LONDON BOROUGH OF ENFIELD

PLANNING COMMITTEE

LOCATION: 1 - 44 Avalon Close Enfield EN2 8LR

APPLICATION NUMBER: 23/00294/FUL

Existing plan – showing exit from existing stair

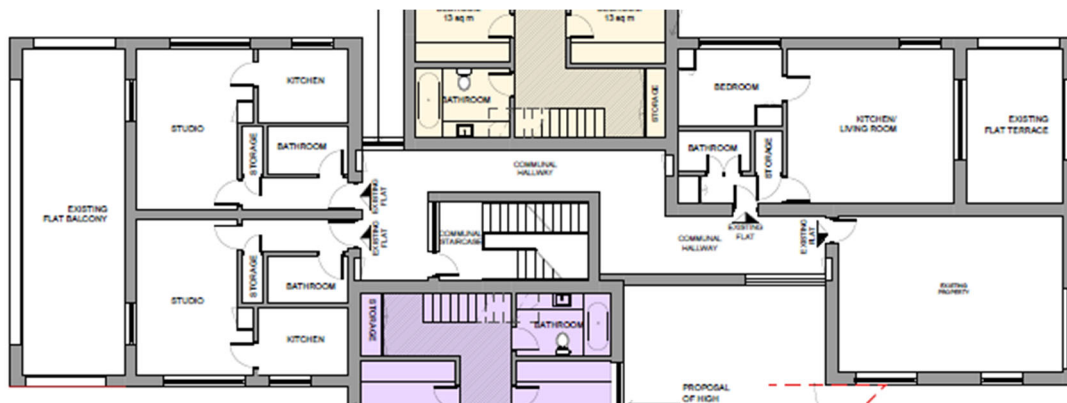
- 9.26 The appeal in 2022 was dismissed because of the relationship between the communal stair and the bathroom windows which open onto the access deck at third floor. The 2021 proposal altered the third floor circulation layout, but the current proposal makes no change to the existing layout at third floor. People approaching existing flats on the third floor would exit the stair at the same place and at the same angle as they currently do. None of the proposed new flats would be accessed at third floor level. This is considered to address, in an acceptable way, the sole reason why the most recent appeal was dismissed.

- 9.27 The third floor as existing, and as proposed under this application, has a circulation area like this:

- 9.30 Under the current proposal, none of the new flats would be accessed at third floor level and the circulation at this level would not change. This means that the reason for dismissal of the most recent appeal has been addressed.

Drawing Title:
Proposed Section AA
Block A & B

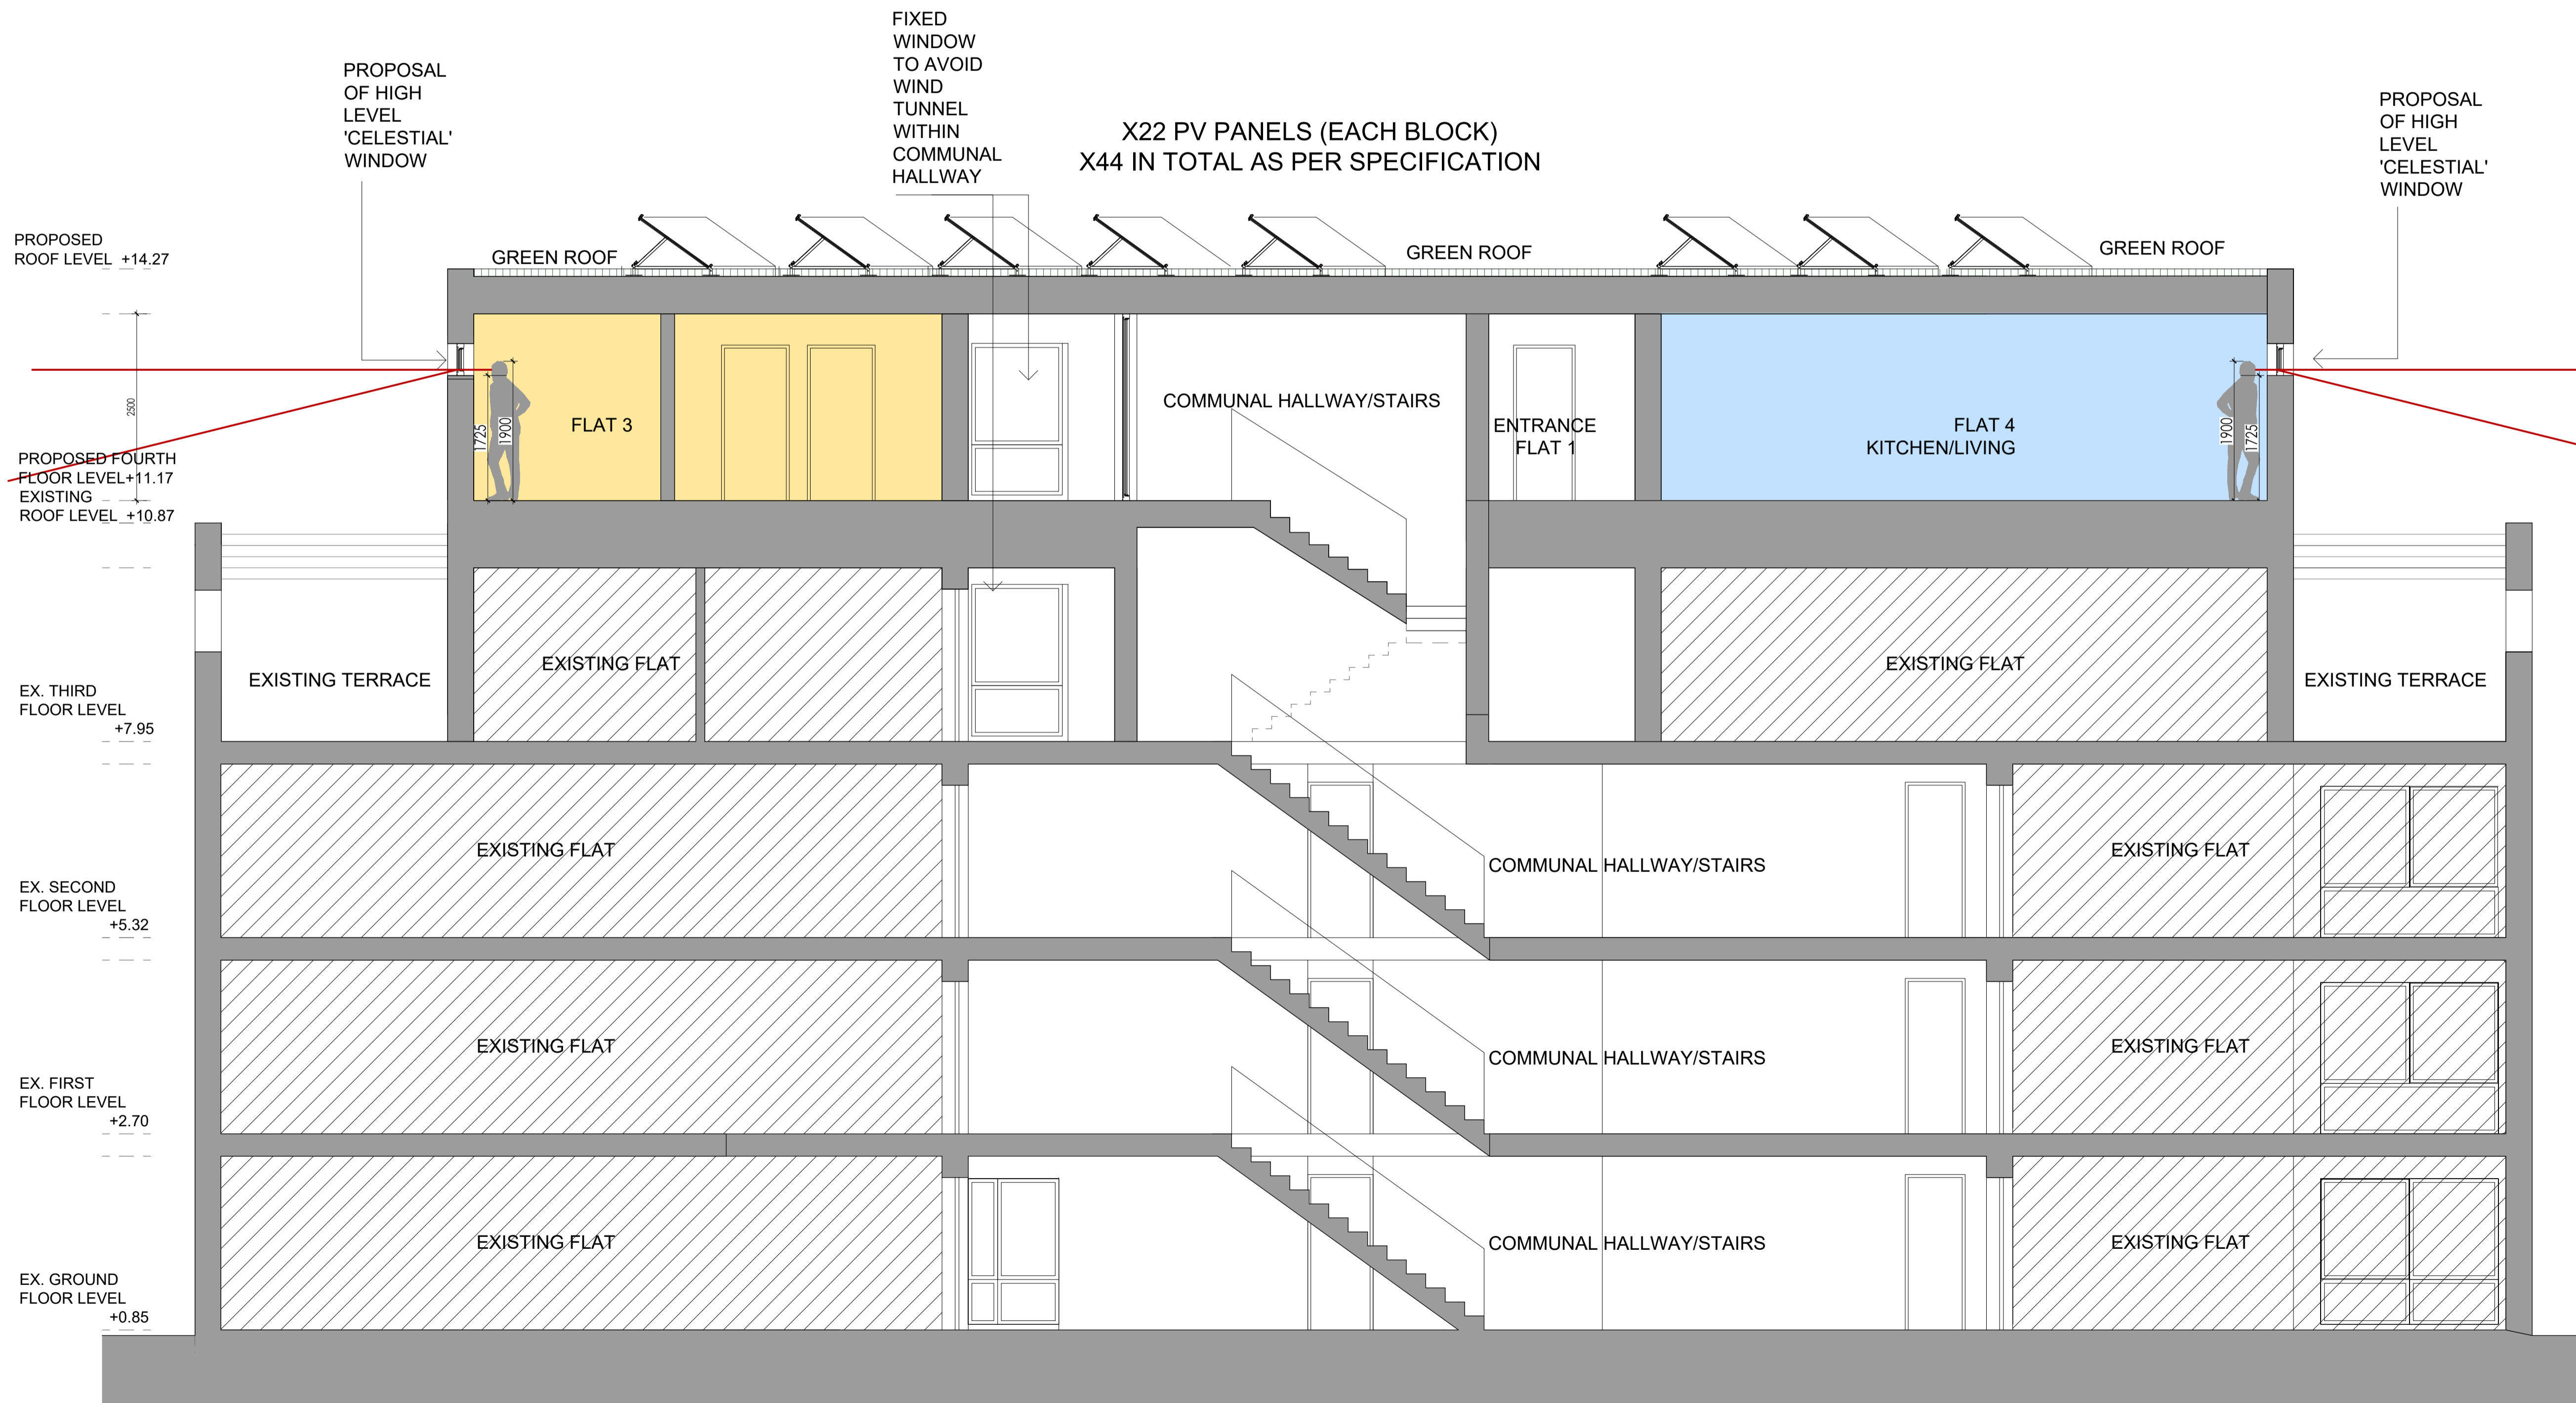
- 9.16 Concerns were raised about the section plans, specifically the roof build up details, possibly not being correct and revisions have been secured. This revision makes an alteration to the height of about 0.75m.

- 9.18 Comments have been made questioning whether the proposed height would really be the finished building height. The developer was asked to amend the plans in response to concerns from residents about changes to the roof structure and this resulted in the increase in height. Should a further increase in height be required for structural reasons after planning permission is granted then the applicant would have to apply to the local planning authority for a determination as to whether an amendment application would be required. This application however has to be assessed and determined on the basis of the information submitted.

- 9.17 The increase in height of the building is not of itself a reason to refuse the proposal. The height of the blocks would increase from 10.87m at the higher existing level to 14.27m overall. Previous applications have not been refused, nor appeals dismissed, on this basis. At the time when the last application was refused the overall height proposed was about 0.75m less than that proposed now however the first application proposed a height of 14.46m. The Inspector at the first appeal did not identify any harm due to the height. While this change in height is a material alteration to the scheme as proposed when this application was initially submitted it is not considered that, in the context of the scheme overall, this would tip the balance of acceptability of the design.
